Bulletin No.: PIT5666

PIT5666 Squeak/Creak/Squawk/Itch Type Noise Heard From The I/P or Center Console Area

Brand:	Model:	Model Years:	VIN:		Engine:	Transmissions:
			from	to		
Chevrolet	Silverado 1500 (New Model)	2019	All	All	All	All
GMC	Sierra 1500 (New Model)	2019	All	All	All	All

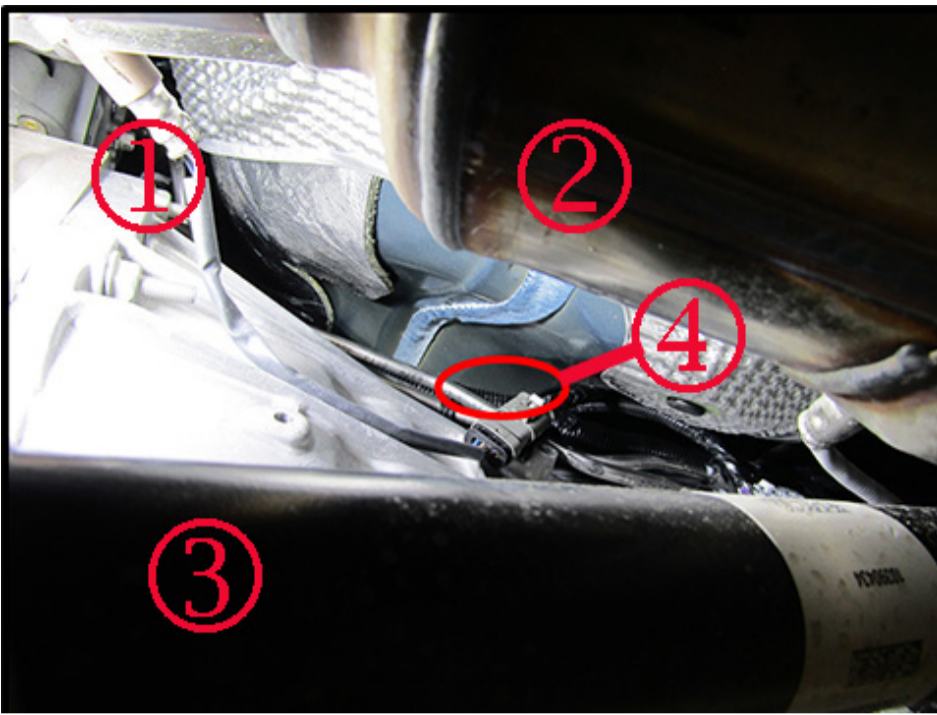
Involved Region or Country	North America
Condition	<p>Some customers may comment of a squeak, creak, itch, or rubber type noise heard from the IP dash or center console area. The noise may be duplicated by the following:</p> <ul style="list-style-type: none"> - Driving over bumps (noise may go away if coasting or if transmission is shifted into "N") - During acceleration - Brake torqueing in drive (noise may not occur when brake torqueing in reverse)
Cause	<p>This noise could be caused by the engine harness rubbing on the floor pan above the transmission (item numbers 4 and 5), as shown below. The photos below were taken from under the vehicle looking up along the driver's side of the transmission bell housing.</p> <p>Callout 1 - Bank 1 Sensor 1 O2 sensor Callout 2 - Bank 1 Catalytic Converter Callout 3 - Front Driveshaft (on 4WD vehicles) Callout 4 - Engine Harness rubbing on floor pan Callout 5 - Engine Harness pushed aside to show the contact on the floor pan</p>

Reposition and secure the engine harness down beside the fuel/evap lines so it no longer contacts the floor pan, as shown below. The rear transmission crossmember may need to be removed so that the transmission can be slightly lowered to gain access to the area. To allow enough slack in the engine harness to reposition it down beside the fuel/evap lines, it needs to be moved/repositioned forward in the clips at the rear of the harness above the rear of the transmission/transfer case. First, release the rear harness clips and move/reposition the harness forward in

the clips, then lock the clips closed. This will create enough slack in the harness to reposition and secure the harness down beside the fuel/evap lines, as shown below.
